Access Compliance Report Public Rights-of-Way (Curb Ramps)

Main Street: HUNTLEY_DR Cross Street: WEATHERBY_RD Location: NW

ADA ID: RPRK211217123057 Ramp Type: Type 1 - Perpendicular Diagonal Initial Pass/Fail: Pass Overall Compliance: No Severity Score: 6

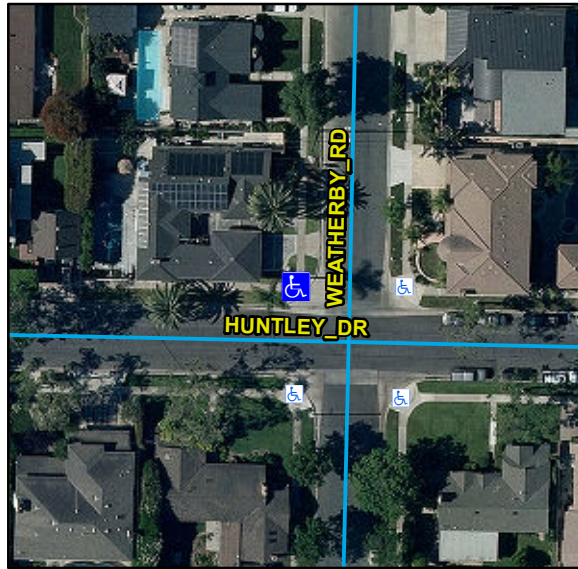
Compliance	Description	Data	Compliance	Description	Data
N/A	Ramp Length (in)	80	N/A	Flare Type LT	
Yes	Ramp Width (in)	48			Sloped
Yes	Ramp Run Slope (%)	7.8	N/A	Flare Slope LT (%)	4.7
Yes	Ramp Cross Slope (%)	0.2	N/A	Flare Traversable LT	No
N/A	Landing Present	Yes	N/A	Flare Type RT	
N/A	Landing Length (in)	49			Sloped
Yes	Landing Width (in)	48	N/A	Flare Slope RT (%)	5.8
No	Landing Run Slope (%)	3.2	N/A	Flare Traversable RT	No
Yes	Landing Cross Slope (%)	1.1	Yes	DWS Provided	Yes
N/A	Landing Movement Obstructed?	No	Yes	DWS Contrast	Yes
	Landing Movement Type	N/A	Yes	DWS Length (in)	36
N/A	Landing Shared	No	Yes	DWS Full Width	Yes
N/A	Clear Space	Yes	Yes	DWS Offset Left (in)	1
N/A	Clear Space To Crosswalk (in)	48	Yes	DWS Offset Right (in)	N/A
N/A	Marked Crosswalk 1	No	N/A	Marked Crosswalk 2	No
	Crossing 1 Direction	S		Crossing 2 Direction	E
	Marked Crosswalk 1 Width (in)	N/A		Marked Crosswalk 2 Width (in)	N/A

N/A	Ramp Inside Crosswalk 1	N/A	Yes	Ramp Inside Crosswalk 2	N/A
	Crossing 1 Slope (%)	5.3		Crossing 2 Slope (%)	4.1
	Crossing 1 Cross Slope (%)	0.2		Crossing 2 Cross Slope (%)	1.6
No	Gutter Ponding	Yes	Yes	Curb Slope	3.7
Yes	Gutter Lip Height (in)	0		Road Run Slope (%)	0.9
No	Gutter Run Slope (%)	5.7		Road Cross Slope (%)	0.2
Yes	Gutter Cross Slope (%)	0.3			
Yes	Overall Surface Condition: Acceptable		Yes	Perp Joint Present	Yes
	Cross Gutter Present?	Yes		Spandrel Present?	Yes
	Replace Cross Gutter?	No		Replace Spandrel?	No

Remove & Replace Landing. Remove & Replace Gutter.
